Enclosed are amended PUD documents for

The Grove at Shoal Creek

## The Grove at Shoal Creek Planned Unit Development Parks Plan Exhibit

AMENDED Land Use Plan  
VERSION 2016-06-16

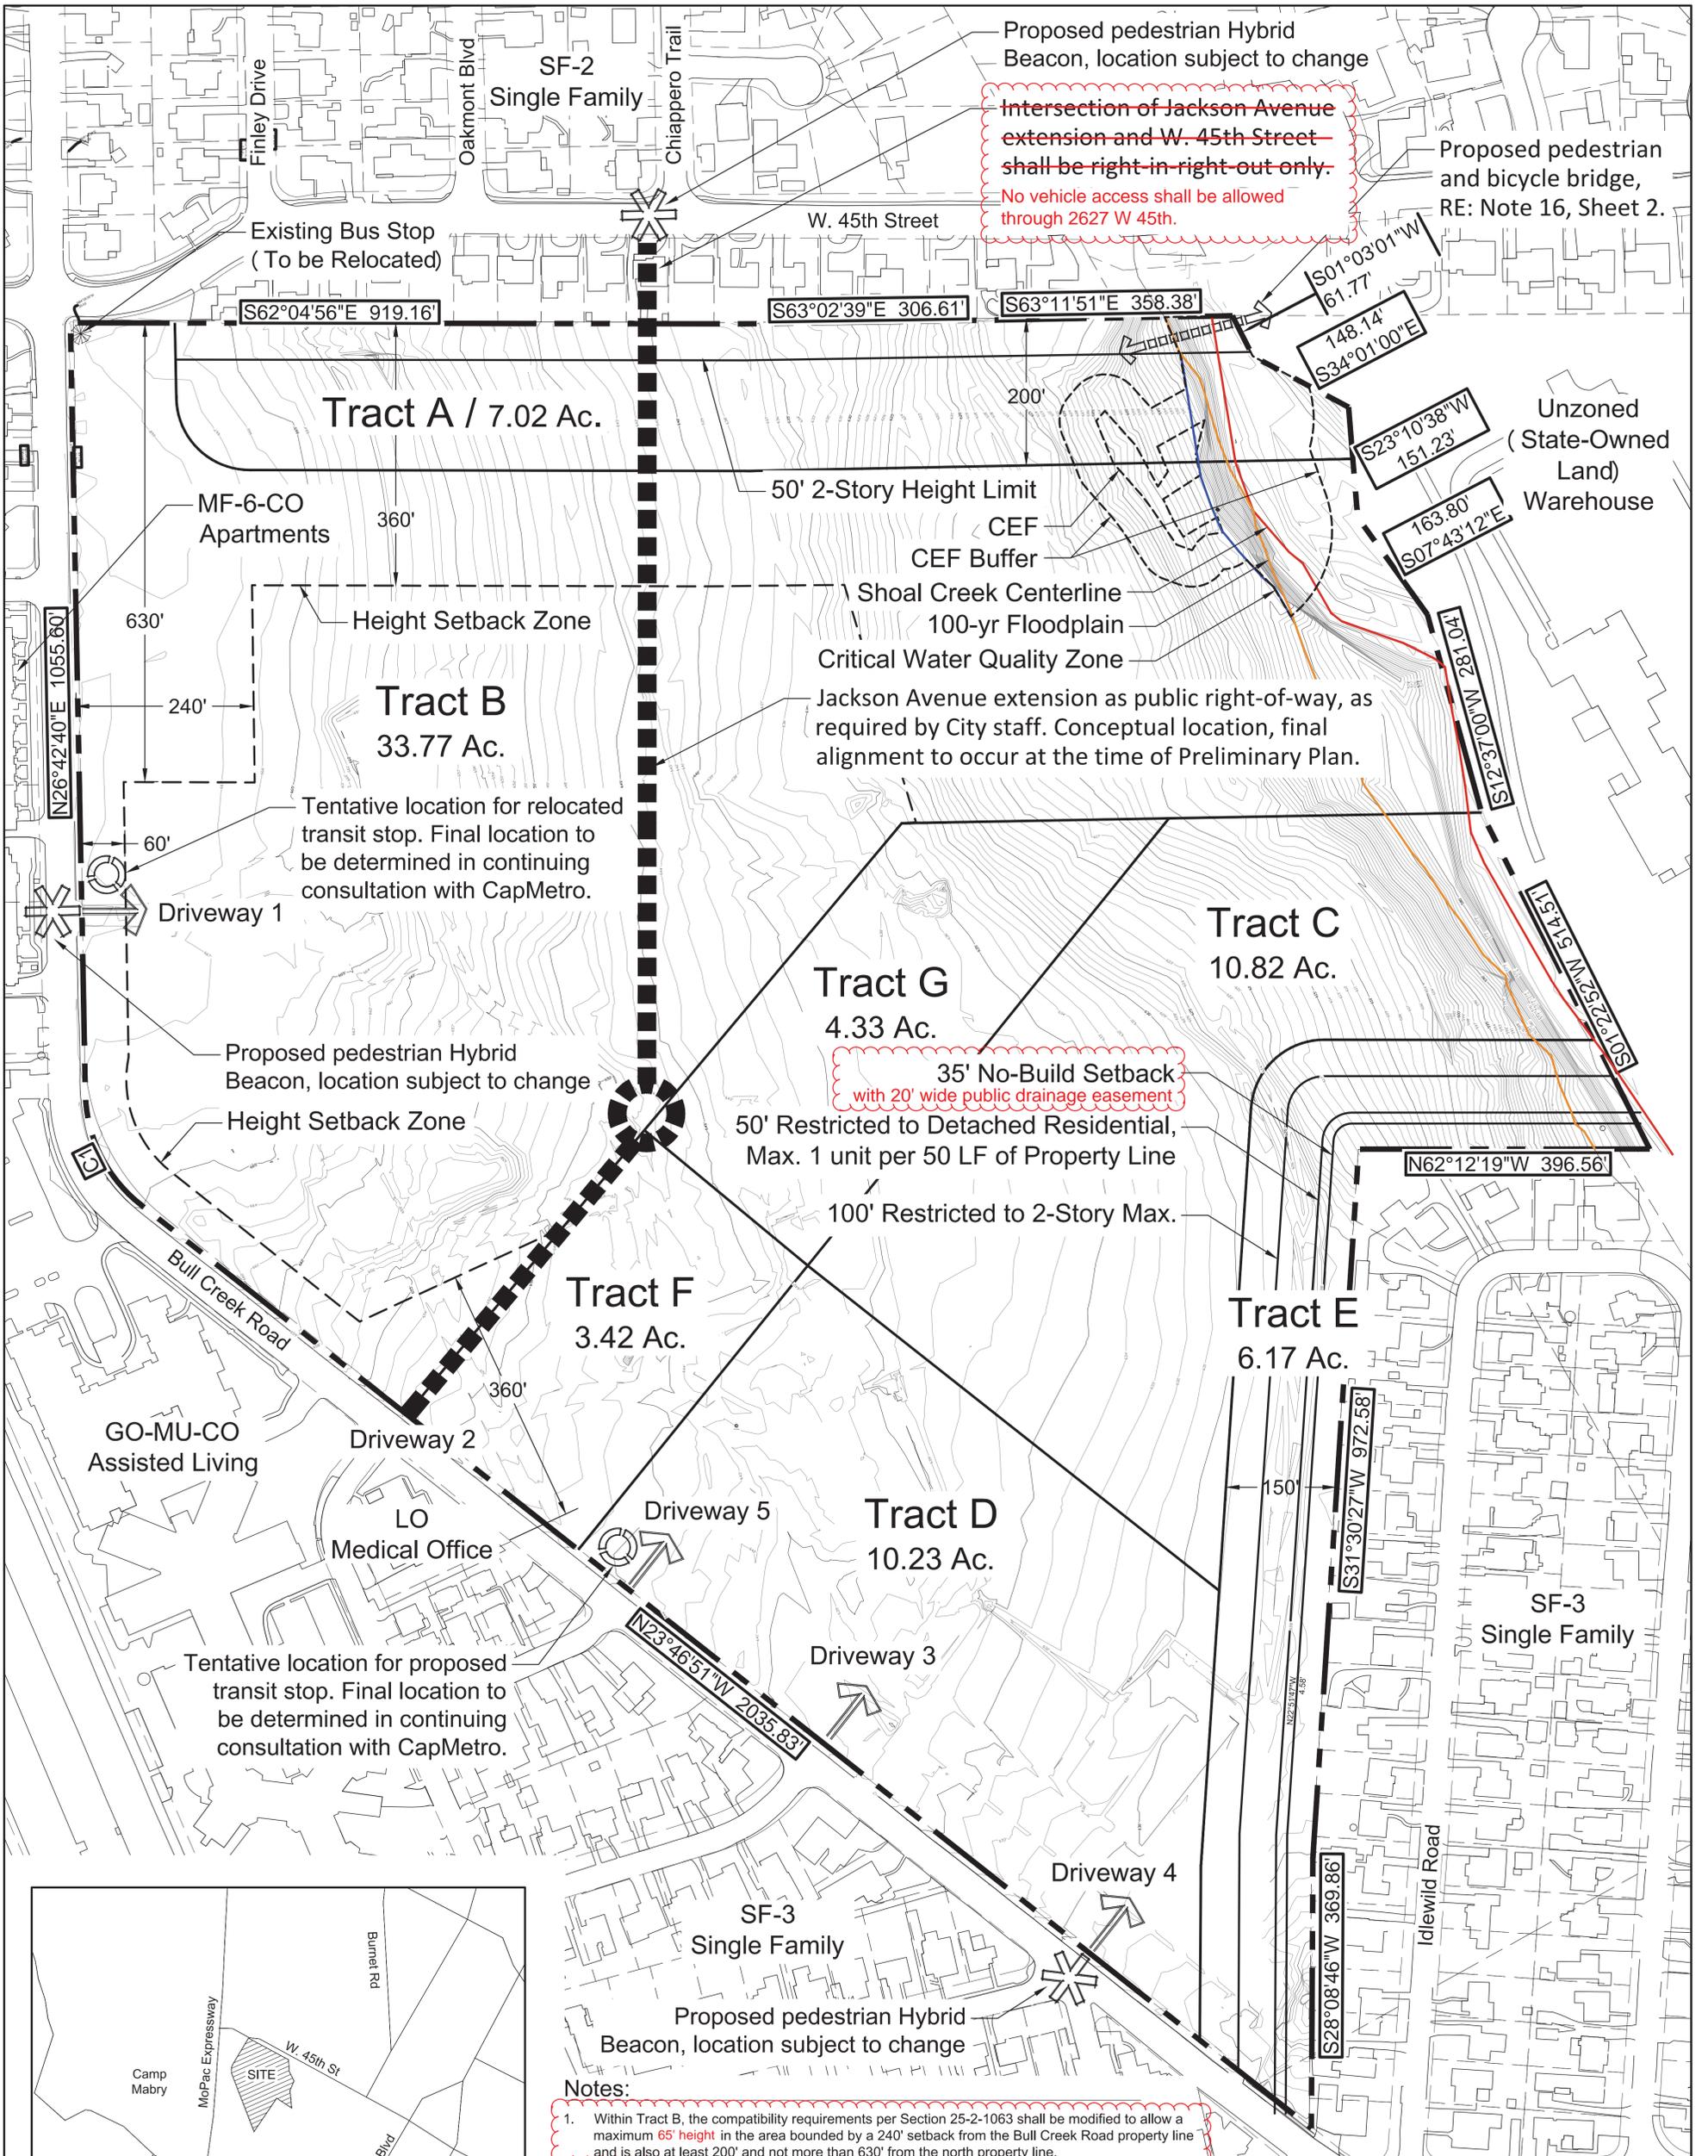
- 0.5 acre added to north greenbelt, allow alleyway use within greenbelt
- 1 acre parkland added to "Signature Park" for protected tree preservation, more street frontage, more active recreation area
- Approximate expected erosion boundary, floodplain, or creek bank
- More accurate location of internal greenbelt
- 2.5 acres parkland added to "Neighborhood Park" for active recreation, potential off-leash area away from Shoal Creek, potential community pool, and more street frontage
- 2 acres parkland added for south greenway for increased trail connectivity to "Signature Park" and space along downstream property line for flood mitigation improvements

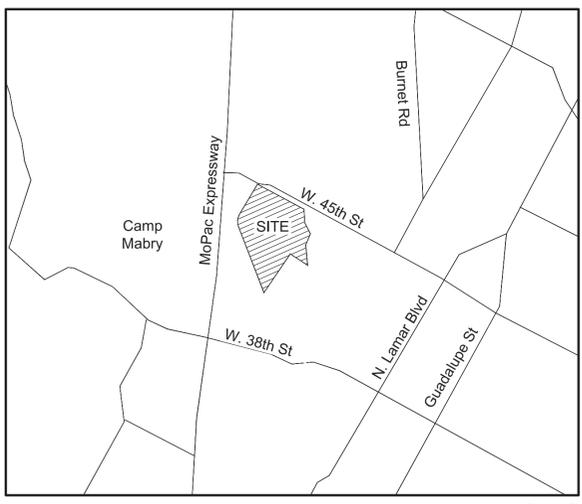
~~Intersection of Jackson Avenue extension and W. 45th Street shall be right-in-right-out only. No vehicle access shall be allowed through 2627 W 45th.~~

- The applicant shall provide and maintain an effective berm/swale system within the 20' wide drainage easement the full length of Tract G.
- The applicant shall prepare and implement a City-approved noise mitigation plan for both permanent and temporary uses and on-site activities including park events, amplified noise from retail and amphitheater, loading and delivery areas, and construction activities, especially these activities occurring adjacent to existing residential uses.
